**"CCO DRAFT"**  
 08/25/2010

**ROADWAY LIGHTING POLE AND FIXTURE SCHEDULES**  
**SHEET 2 OF 9**  
 NO SCALE

CONTRACT CHANGE ORDER No. 170  
 SHEET \_\_\_\_\_ OF \_\_\_\_\_

**ROADWAY LIGHTING POLE  
 PLAN LOCATION-SHEET 15  
 SKYWAY STRUCTURES**

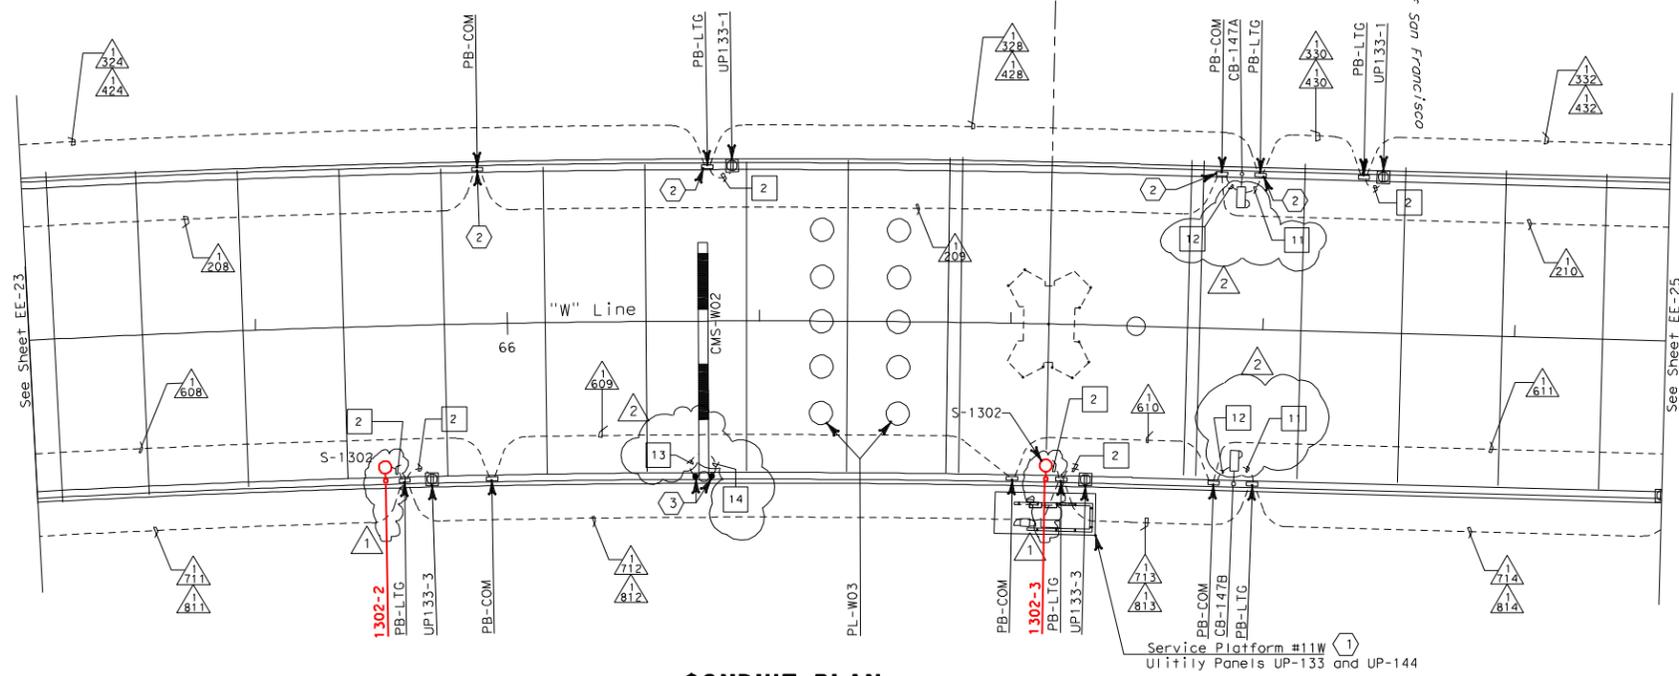
MARK	DATE	DESCRIPTIONS	REV	CK
2	1/20/06	Delete CB-147A & CB-147B. Coil 5 m of call box signal and power cable in adjacent PB-COM and PB-LTG pull boxes & Deleted CMS cable harnesses only.	JE	EJL CCO No. 170
1	3/2/05	Delete Roadway light poles and fixtures. Coil 10m, 3#10 conductors in the pull box adjacent to light pole locations.	RS	PB CCO No. 123

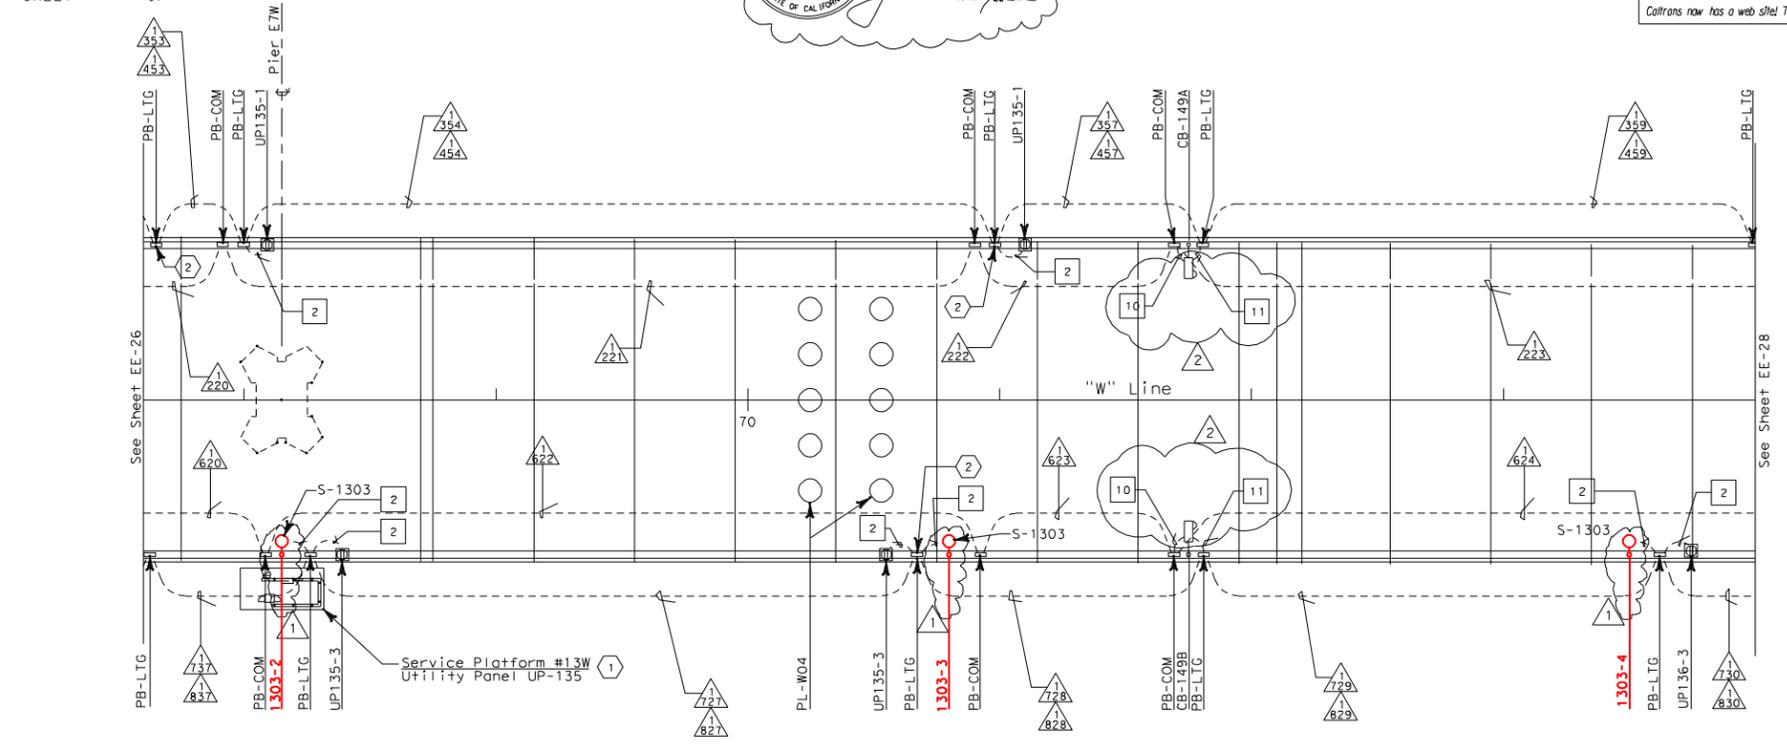
MARK	DATE	DESCRIPTIONS	REV	CK
2	1/20/06	Delete CB-149A & CB-149B. Coil 5 m of call box signal and power cable in adjacent PB-COM and PB-LTG pull boxes.	JE	EJL
1	3/2/05	Delete Roadway light poles and fixtures. Coil 10m, 3#10 conductors in the pull box adjacent to light pole locations.	RS	PB

**ROADWAY LIGHTING POLE  
 PLAN LOCATION-SHEET 21  
 SKYWAY STRUCTURES**  
 NO SCALE

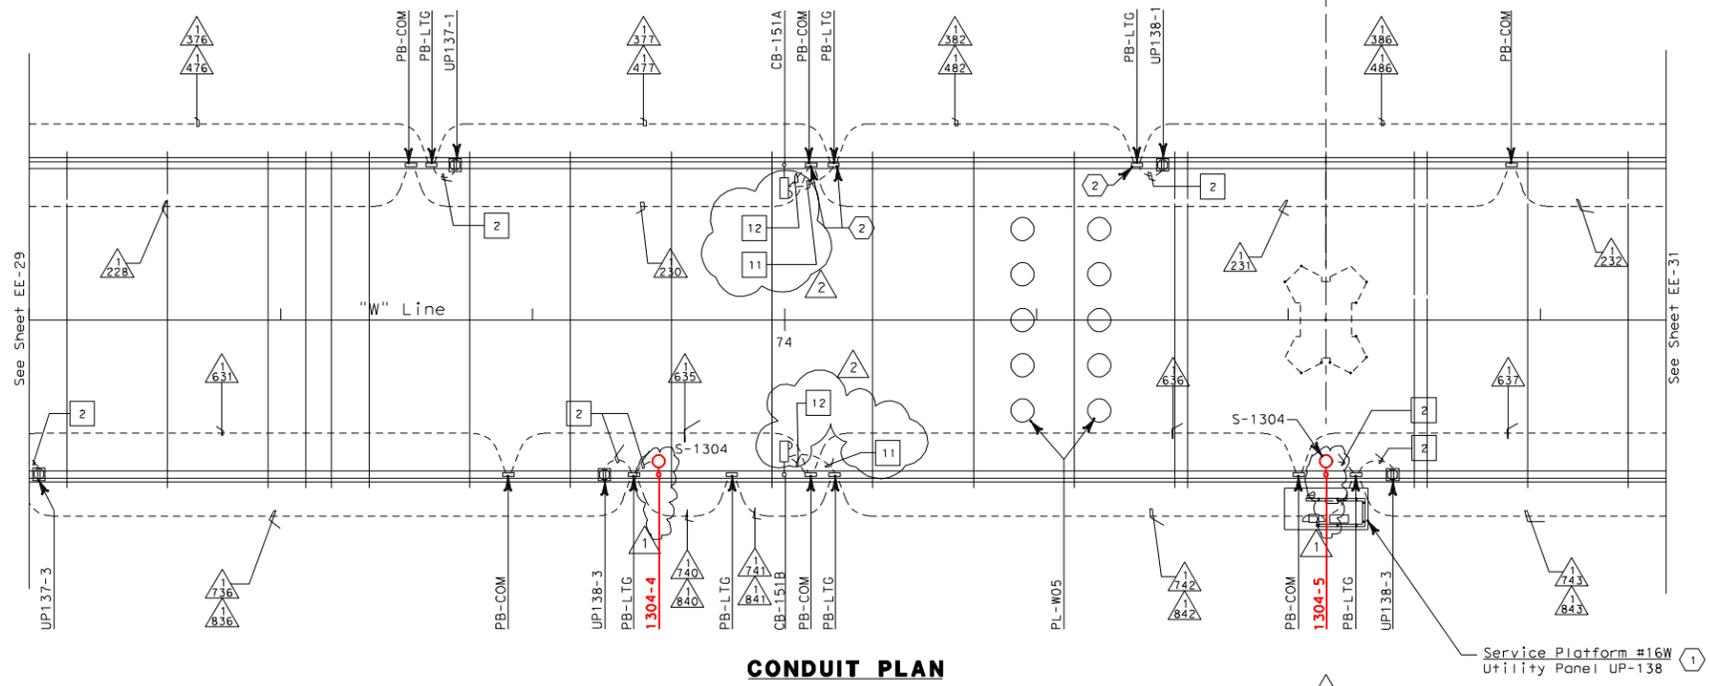
MARK	DATE	DESCRIPTIONS	REV	CK
2	1/20/06	Delete CB-151A & CB-151B, Coil 5 m of call box signal and power cable in adjacent PB-COM and PB-LTG pull boxes.	JE	EJL
1	3/2/05	Delete Roadway light poles and fixtures, Coil 10m, 3#10 conductors in the pull box adjacent to light pole locations.	RS	PB

**ROADWAY LIGHTING POLE  
 PLAN LOCATION-SHEET 22  
 SKYWAY STRUCTURES**  
 NO SCALE

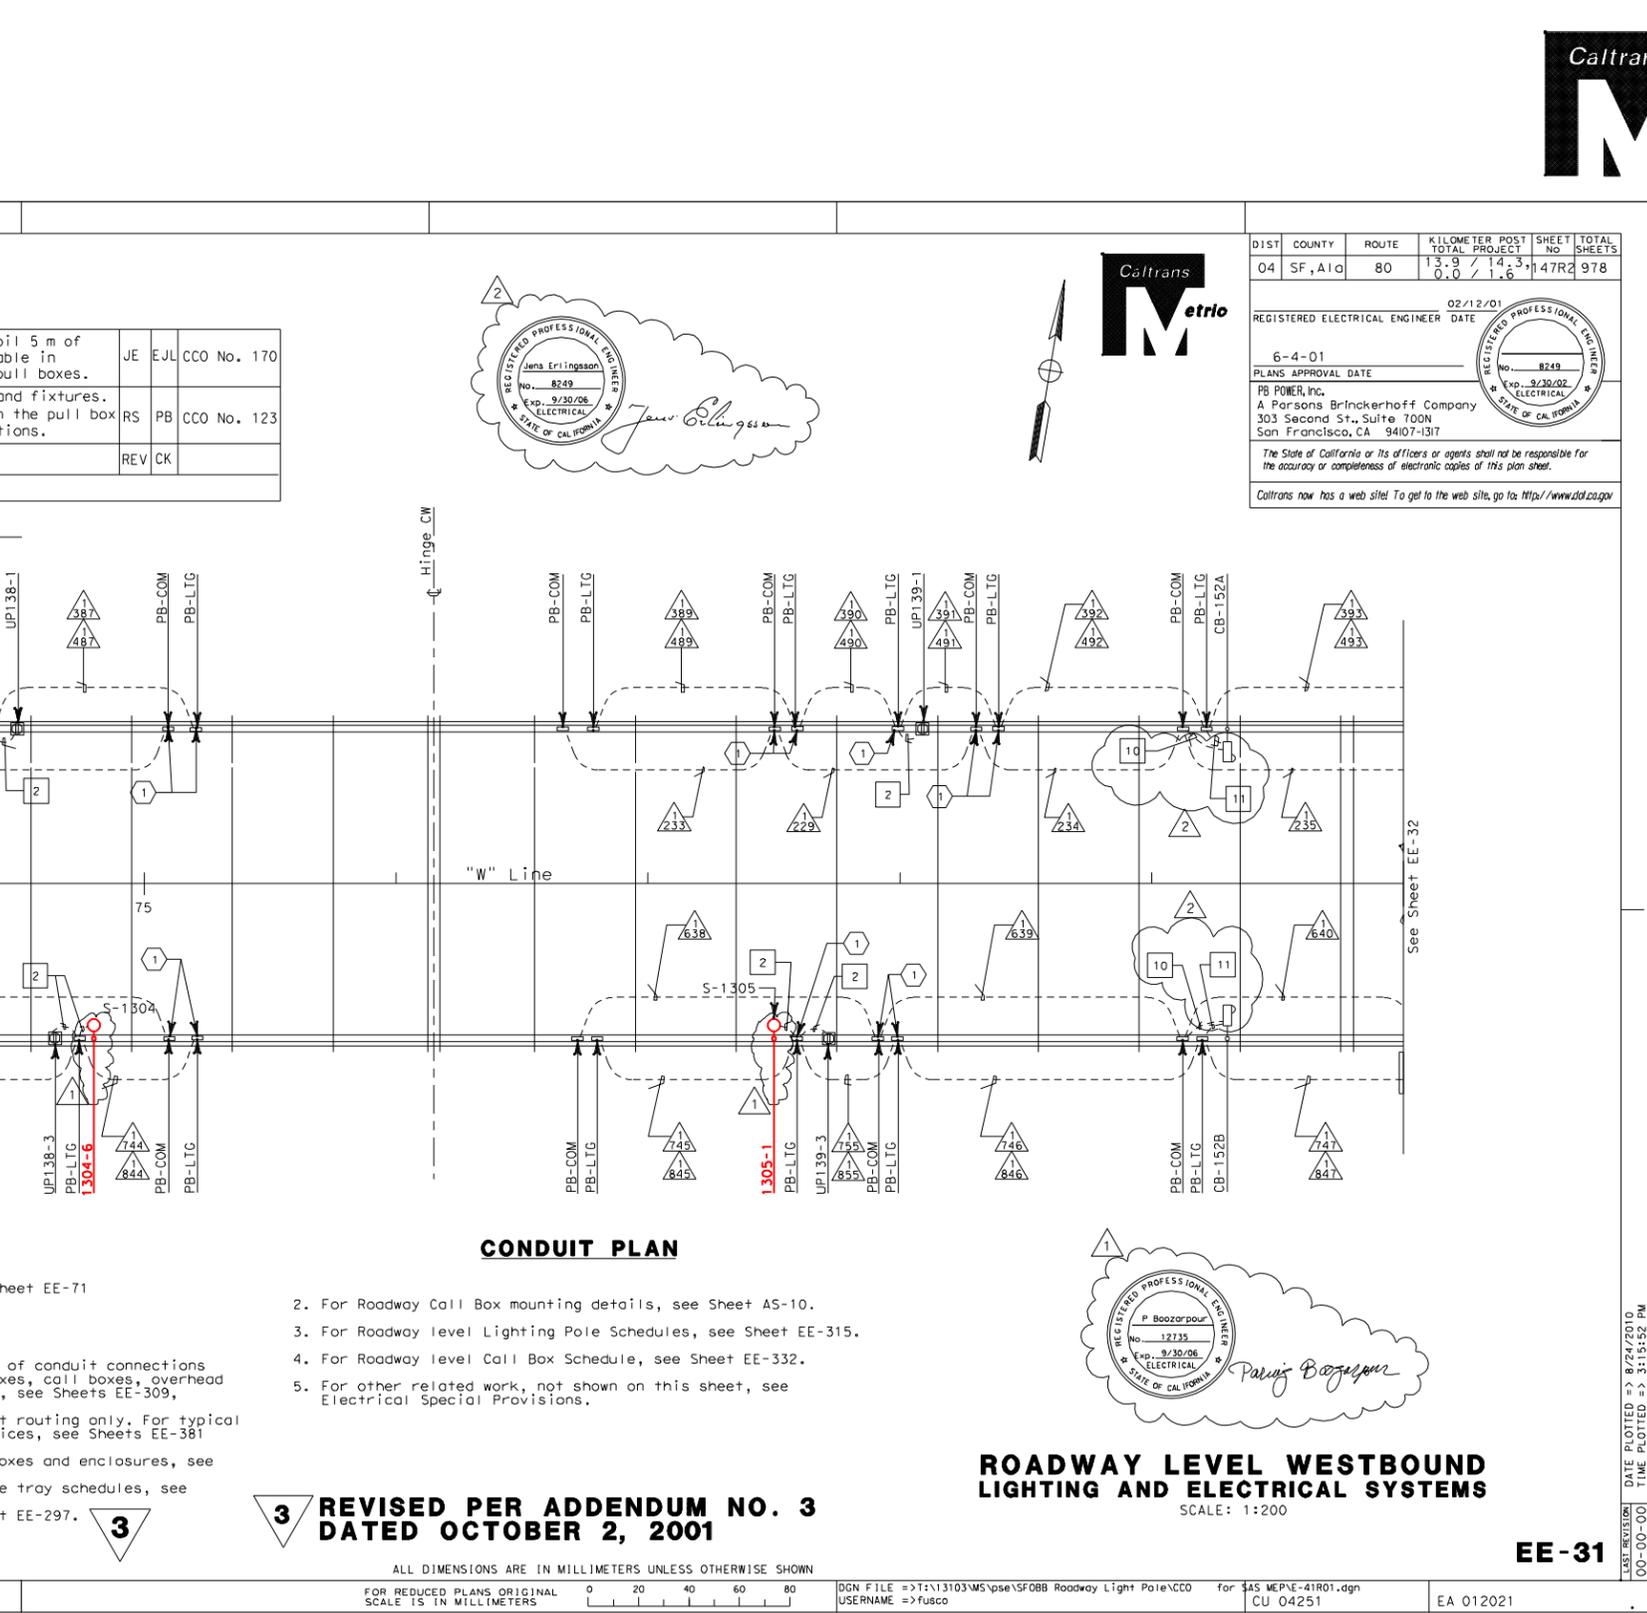
REVISIONS	MARK	DATE	DESCRIPTIONS	REV	CK
2	1/20/06		Delete CB-152A & CB-152B. Coil 5 m of call box signal and power cable in adjacent PB-COM and PB-LTG pull boxes.	JE	EJL CCO No. 170
1	3/2/05		Delete Roadway light poles and fixtures. Coil 10m, 3#10 conductors in the pull box adjacent to light pole locations.	RS	PB CCO No. 123

**ROADWAY LIGHTING POLE PLAN LOCATION-SHEET 26**  
**SKYWAY STRUCTURES**  
 NO SCALE

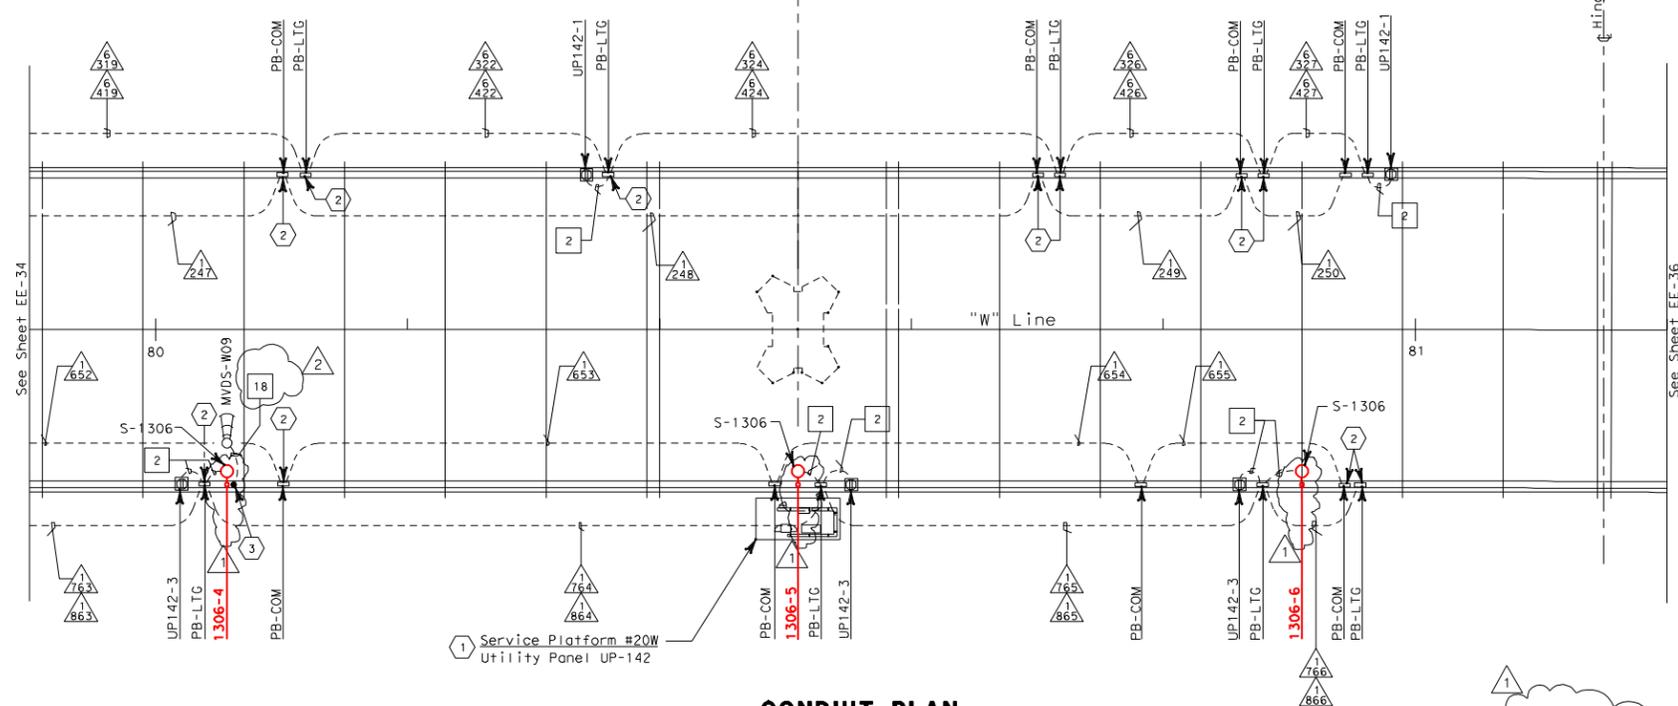
MARK	DATE	DESCRIPTIONS	REV	CK
2	1/20/06	Delete MVDS cable harnesses only.	JE	EJL
1	3/2/05	Delete Roadway light poles and fixtures. Coil 10m, 3#10 conductors in the pull box adjacent to light pole locations.	RS	PB

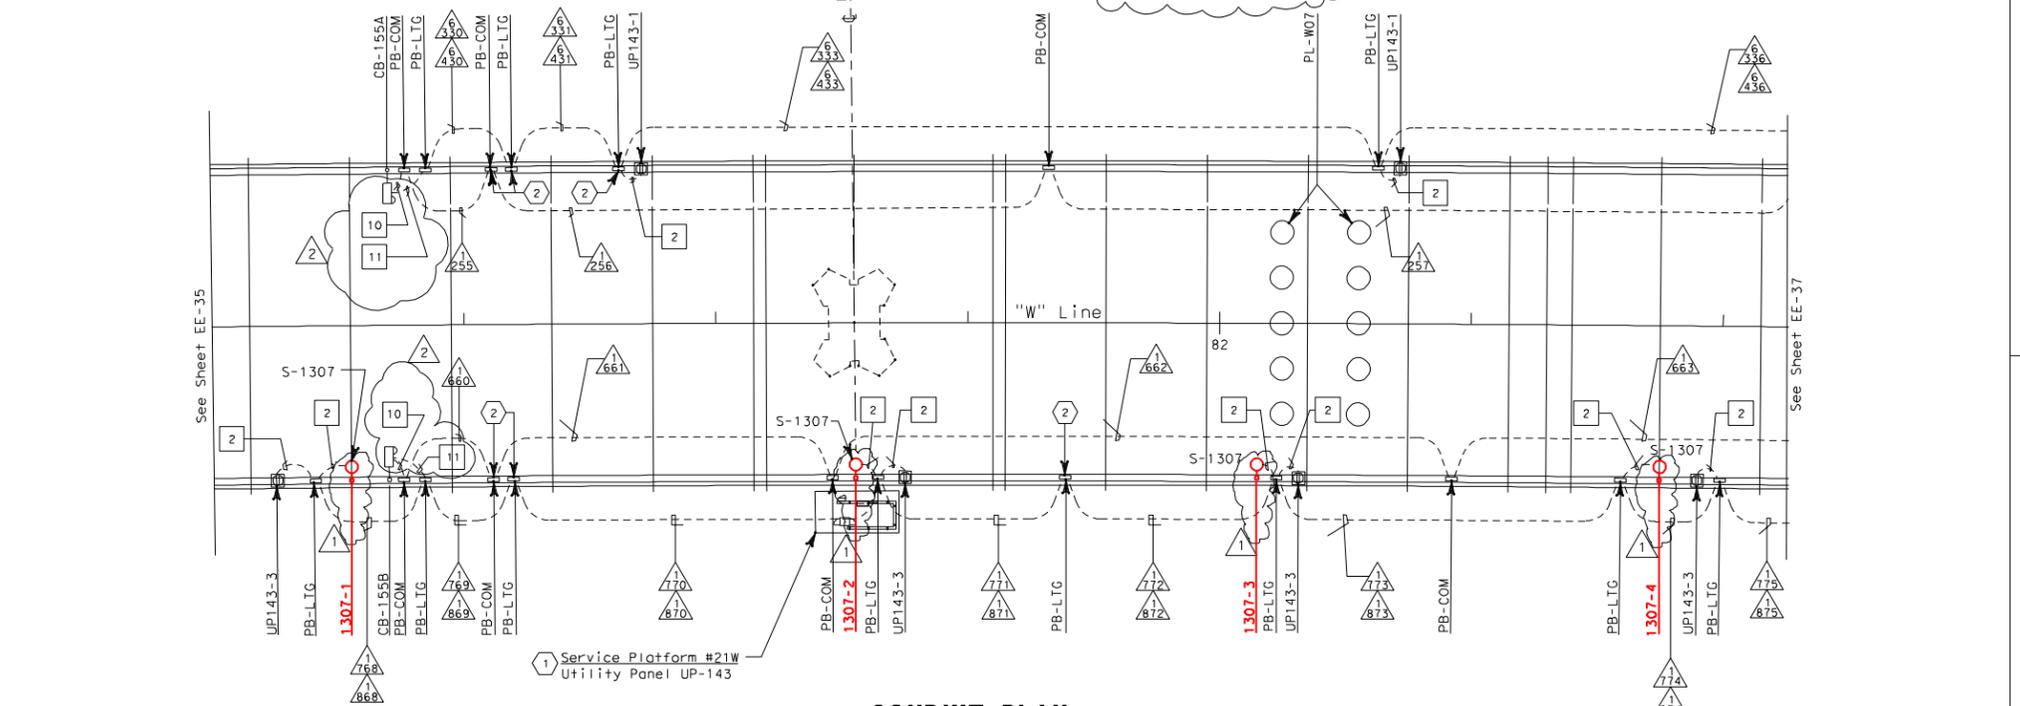
MARK	DATE	DESCRIPTIONS	REV	CK
2	1/20/06	Delete CB-155A & CB-155B. Coil 5 m of call box signal and power cable in adjacent PB-COM and PB-LTG pull boxes.	JE	EJL CCO No. 170
1	3/2/05	Delete Roadway light poles and fixtures. Coil 10m, 3#10 conductors in the pull box adjacent to light pole locations.	RS	PB CCO No. 123

**ROADWAY LIGHTING POLE  
 LOCATION PLAN-SHEET 45  
 SKYWAY STRUCTURES**  
 NO SCALE

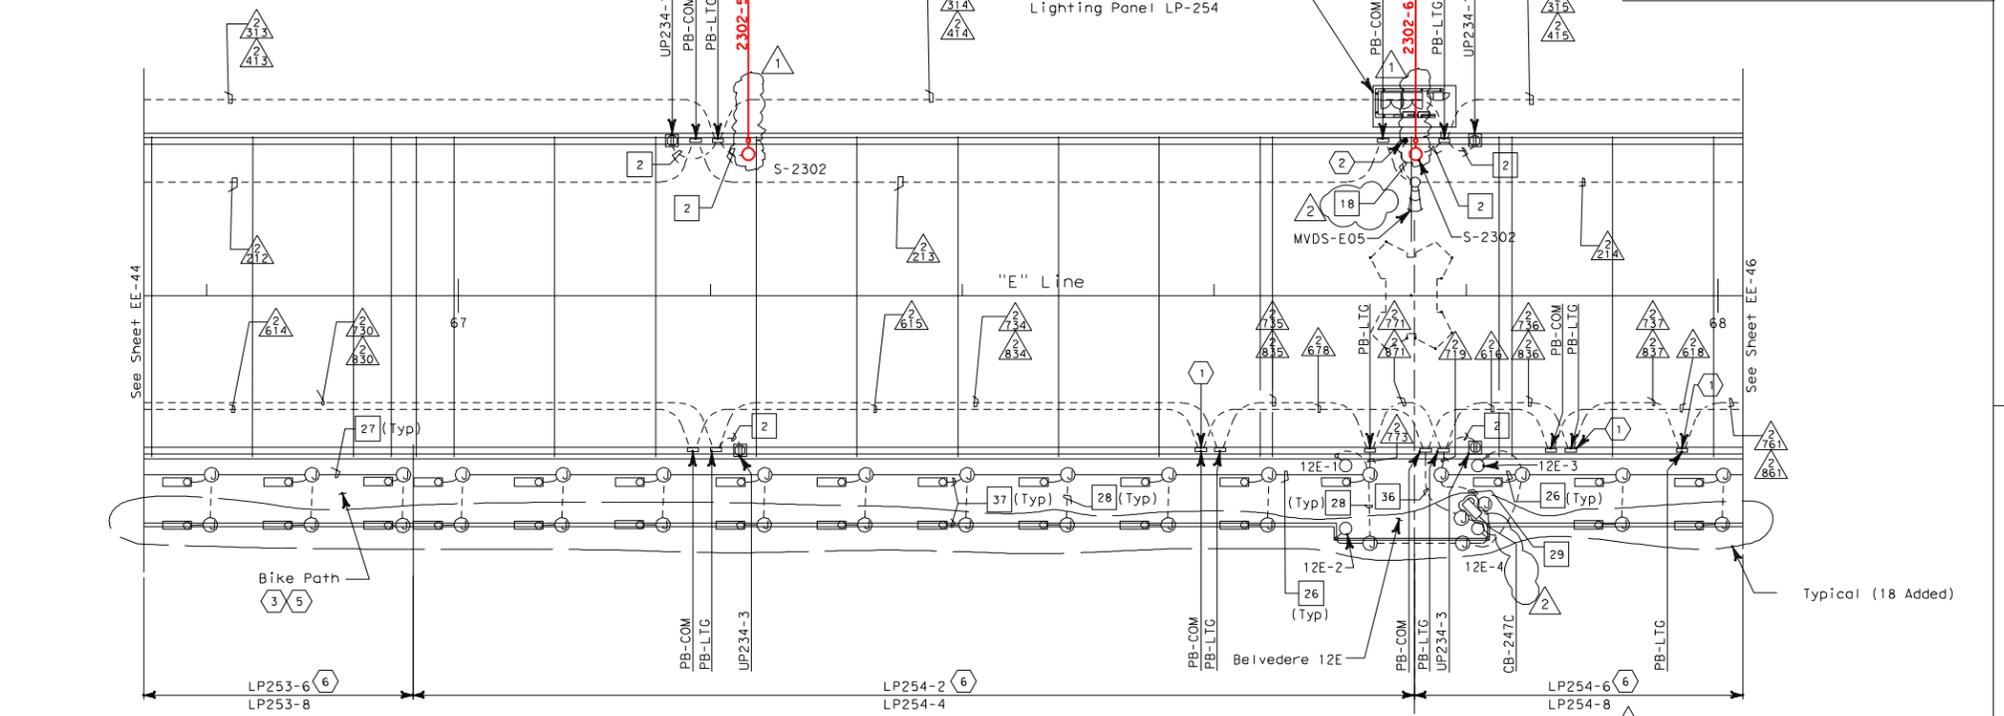
MARK	DATE	DESCRIPTIONS	REV	CK
2	1/20/06	Delete CB-247C. Coil 5 m of call box signal and power cable in adjacent PB-COM and PB-LTG pull boxes. Delete MVDS cable harness only.	JE	EJL
1	3/2/05	Delete Roadway light poles and fixtures. Coil 10m, 3#10 conductors in the pull box adjacent to light pole locations.	RS	PB
